27 October 2023  
Our File Ref: B23312AL001  
Contact: Bridget Wouts

RE: **LINK ROAD MIXED USE PRECINCT – BANKSTOWN AIRPORT**  
**AIRPORT SAFEGUARDING ASSESSMENT – PRELIMINARY ASSESSMENT**

L+R Airport Consulting were engaged by Bankstown Airport Limited (BAL) to undertake an airport safeguarding assessment at key design documentation stages through the Major Development Plan process as it relates to Bankstown Airport against the National Airports Safeguarding Framework (NASF) Guidelines. This assessment is based on the Preliminary Documentation stage.

**BANKSTOWN AIRPORT LIMITED**  
LINK ROAD MIXED USE PRECINCT - AVIATION ASSESSMENT  
**NASF GUIDELINE I - PUBLIC SAFETY AREA - BANKSTOWN AIRPORT MP2019**

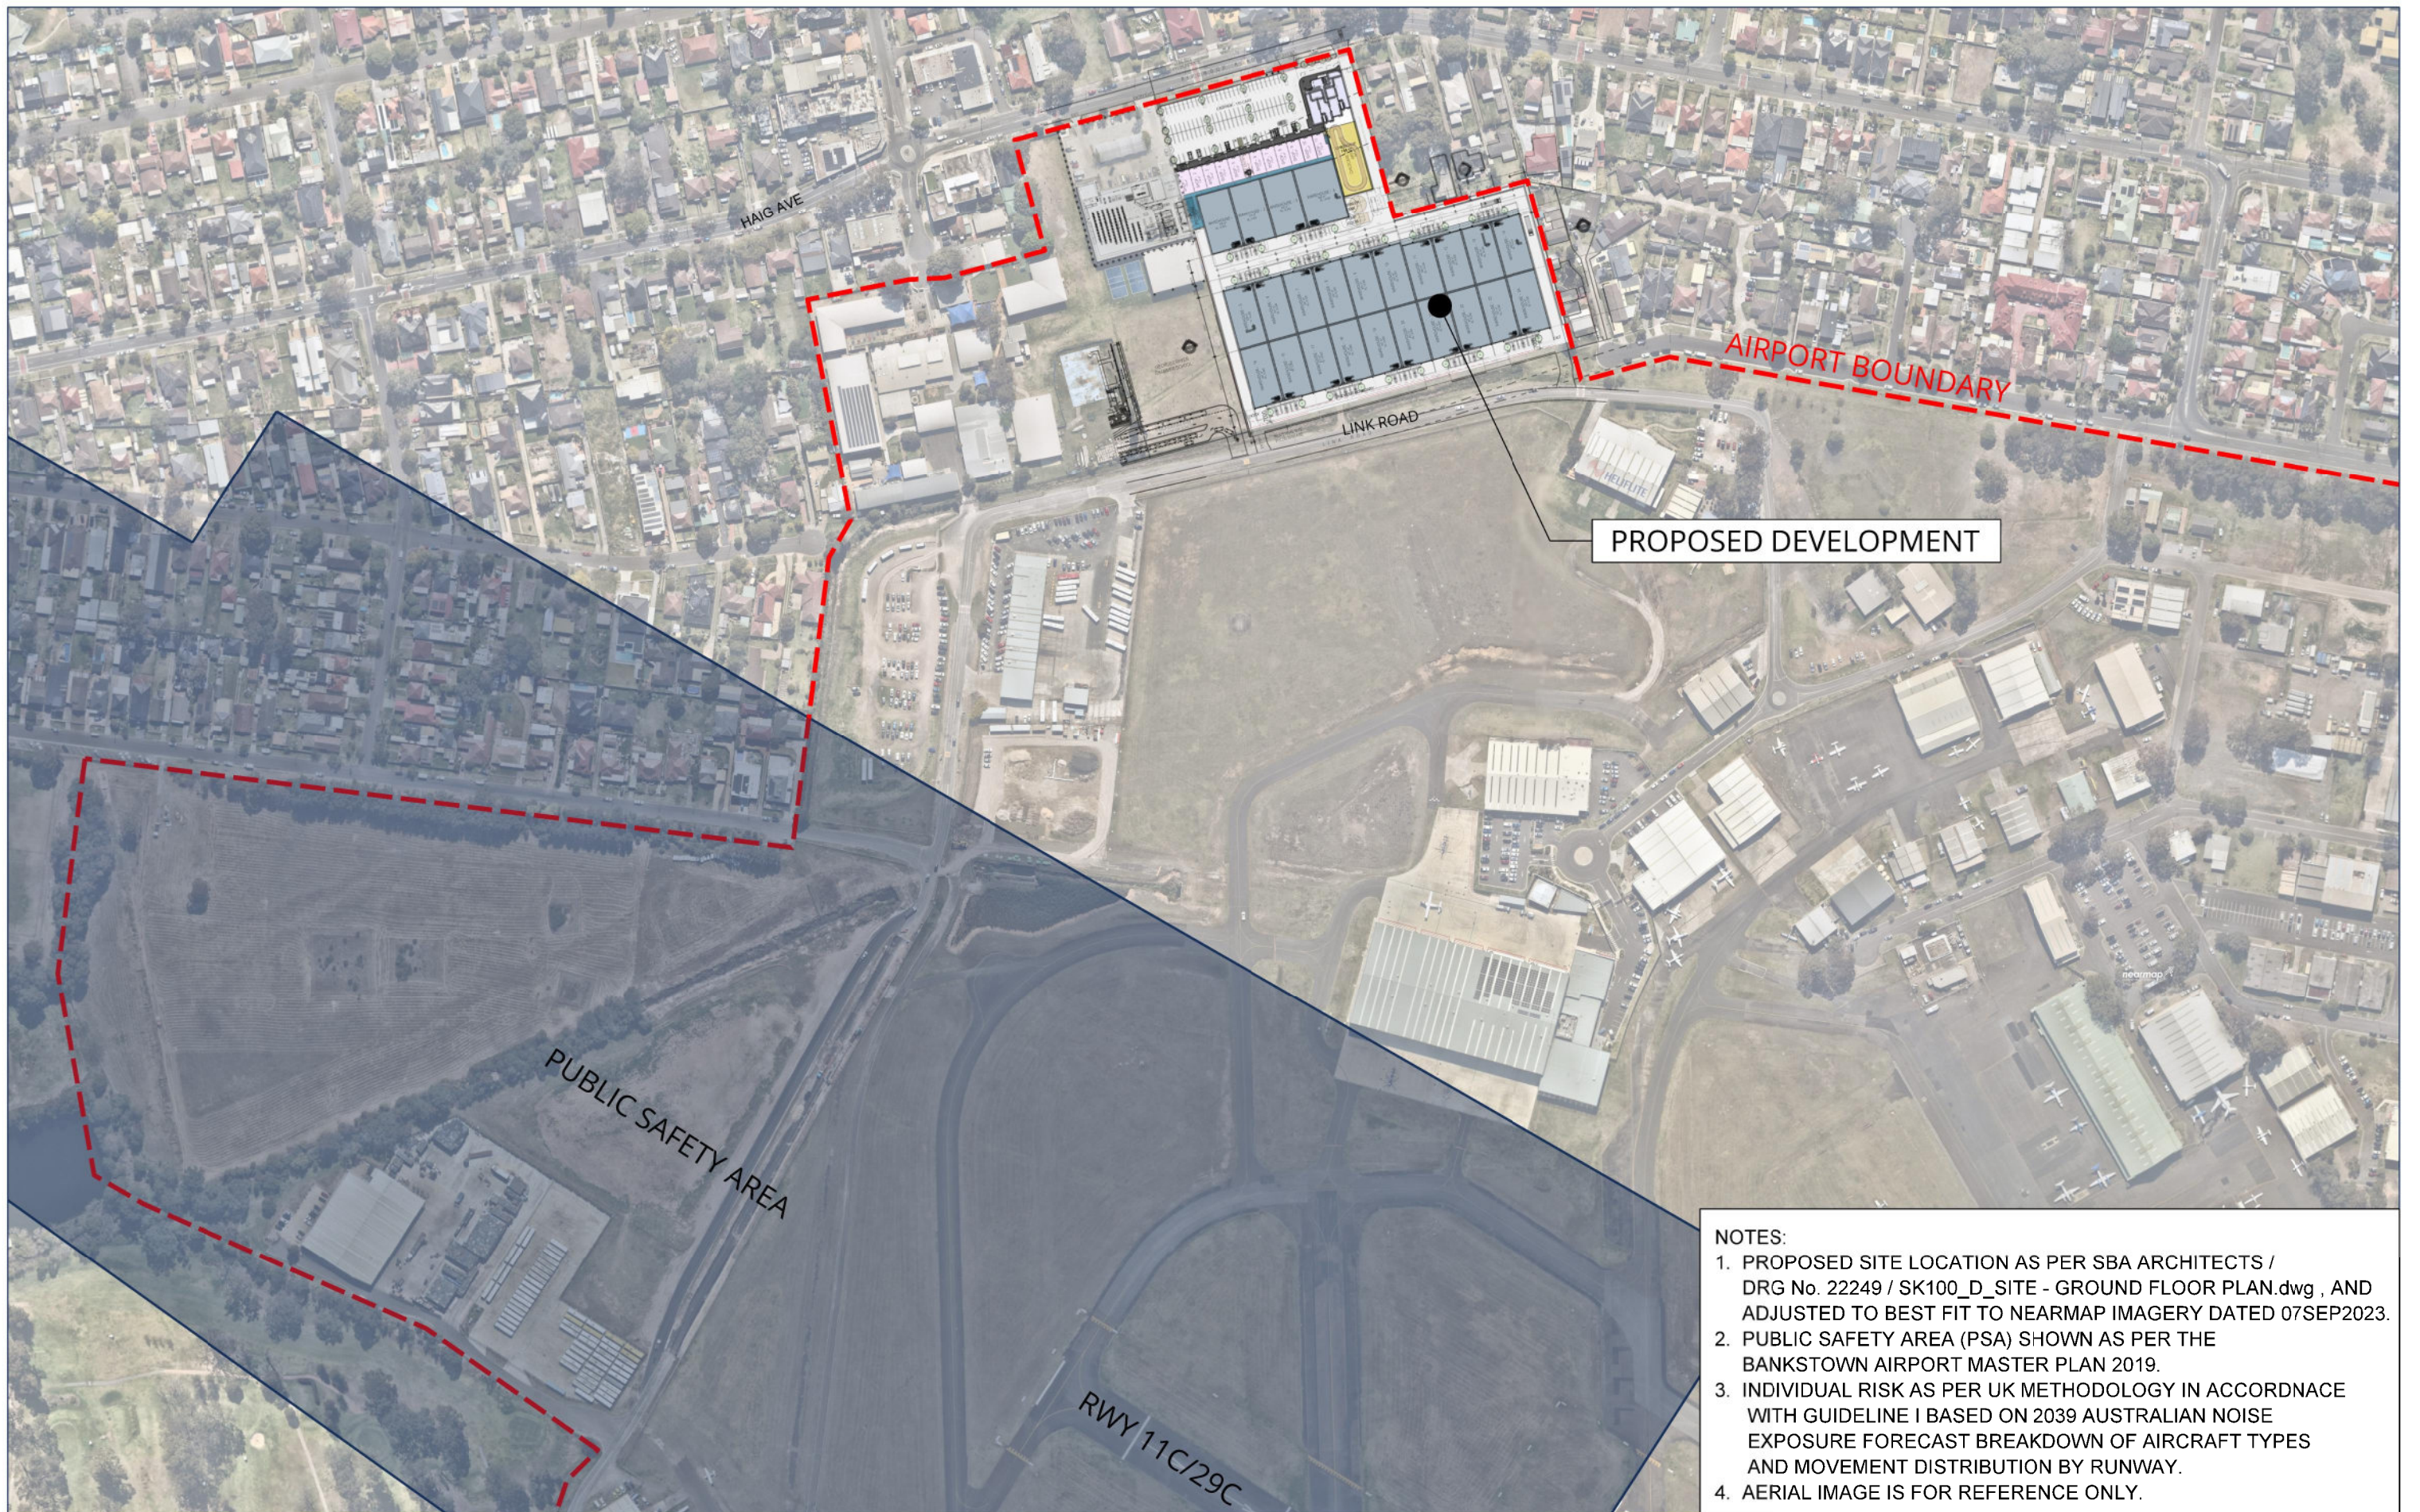
BAL has identified the PSAs at the end of each runway based on the Queensland state planning policy PSA Model, which Guideline I notes as providing an objective basis for a policy response through strategic and statutory planning processes. The proposed development is not within the PSAs as per the Bankstown Airport Master Plan 2019 and illustrated on Figure B23312/10.
